Access Compliance Report

Public Rights-of-Way

(Curb Ramps)

Intersection ID: 42931	Main Street: BRAY_DR	Cross Street: HOLLY_PARK_DR	Location: E
ADA ID: 6F536869DEA8	Ramp Type: PerpDiag	Initial Pass/Fail: Fail	Overall Compliance: No
Severity Score: 33.75			
Codes/Mitigation Info/Possible Solution		Field Measurements/Component Compliance

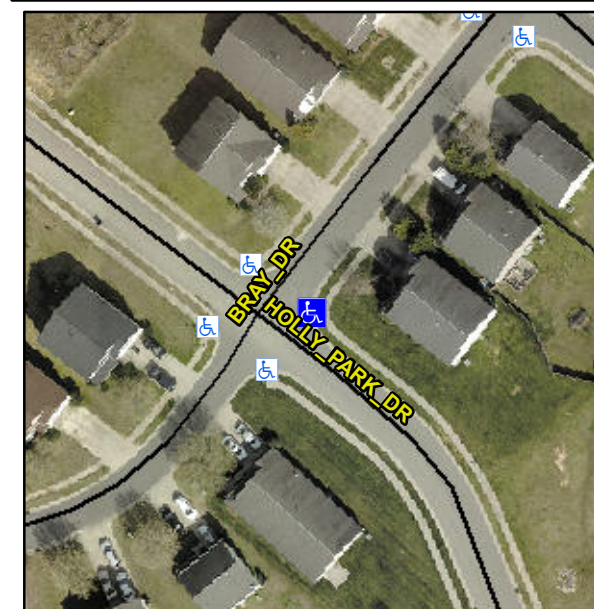
Not Found, R304.5.1, R304.2.2

Compliance	Description	Data	Compliance	Description	Data
N/A	Ramp Length (in)	47.0	No	Ramp Slope (%)	13.1
No	Ramp Width (in)	37.0	Yes	Ramp XSlope (%)	1.6
N/A	Flare Type LT	N/A	N/A	Flare Type RT	N/A
N/A	Flare Slope LT (%)	N/A	N/A	Flare Slope RT (%)	N/A
N/A	Flare Traversable LT?	N/A	N/A	Flare Traversable RT?	N/A
N/A	Landing Length (in)	N/A	N/A	DWS Provided?	N/A
N/A	Landing Width (in)	N/A	N/A	DWS Contrast?	N/A
N/A	Landing Slope (%)	N/A	N/A	DWS Length (in)	N/A
N/A	Landing X Slope (%)	N/A	N/A	DWS Full Width?	N/A
N/A	Landing Curb? (Y/N)	N/A	N/A	DWS Offset (in)	N/A
N/A	Shared Landing?	N/A			
N/A	Gutter Ponding?	N/A	N/A	Gutter Slope (%)	N/A
N/A	Gutter Lip Ht (in)	N/A	N/A	Gutter X Slope (%)	N/A
N/A	Painted X Walk1?	No	N/A	Painted X Walk2?	No
	X Walk 1 Direction	To NW		X Walk 2 Direction	To SW
N/A	X Walk 1 Width (in)	N/A	N/A	X Walk 2 Width (in)	N/A
	X Walk 1 Slope (%)	1.3		X Walk 2 Slope (%)	2.9
	X Walk 1 X Slope (%)	1.1		X Walk 2 X Slope (%)	2.1

Remove & Replace Curb Ramp With Two New Directional Ramps or Equivalent.
